I am writing to you on behalf of the Regent's Canal CAAC in regard to the above application.

West Yard Walk

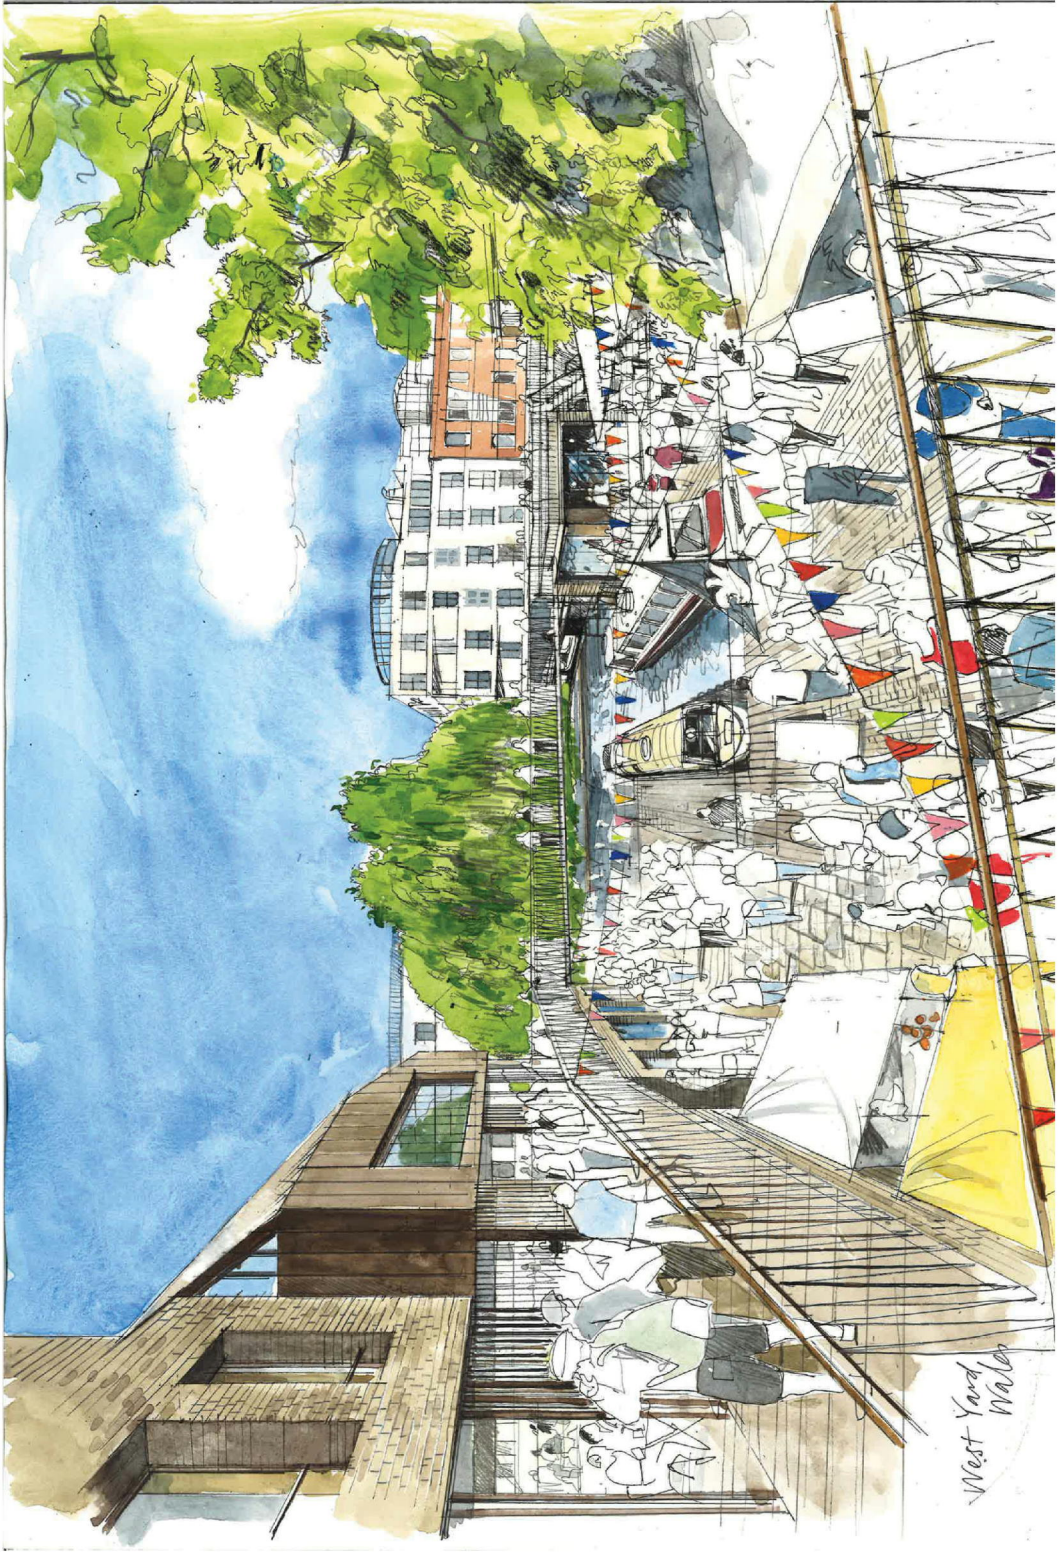
We are currently assembling our comments and will be submitting these in the next week. One feature of the applicant's proposals that gives us some cause for concern is the treatment of the walkway that crosses the site at first floor level from the New Market Building, across Middle Yard as a bridge, across the new range of buildings forming the west side of Middle Yard, and across West Yard as a bridge to terminate on the new one storey building, from where a broad set of stairs lead down to ground level.

This walkway creates a very strong east-west feature that severely challenges the north-south orientation of all the rest of the market. It seems contrary to the Design Principles set out in the Design and Access Statement. Of even greater concern than the impact on the character of the market is the walkway's impact on the Roving Bridge. The Roving Bridge is an iconic feature of the area that is popularly known as Camden Lock, and is arguably the most important feature in that area. It is a highly significant structure in heritage terms, and a candidate for upgrading from II to II\*, an objective that we have been pursuing for some time. The new bridge will be particularly unhelpful in achieving this objective. Apart from its architectural impact, so clearly seen in the artist's impression view from the Roving Bridge, the new bridge obscures the views of the Roving Bridge from the north, as can be appreciated from the view attached, taken from the Design and Access Statement.

We can see that, in principle, there is a very obvious need for such a passage across the site. However, the solution, apart from having the impacts already described, is compromised by what locals (ie those who may wish to avoid the market) must go through at its west end where they will be required to negotiate a set of stairs through crowds of diners before reaching the bottleneck that is the exit onto the towpath.

In contrast to the applicant's justification of the new buildings, notably the range between West and Middle Yard, this major new feature has been entirely ignored in any discussion of design development in the Design and Access Statement. The only discussion is in regard to materials. It is difficult to avoid the impression that the architect would not have included this feature unless it were a requirement of his brief. We have queried this with the
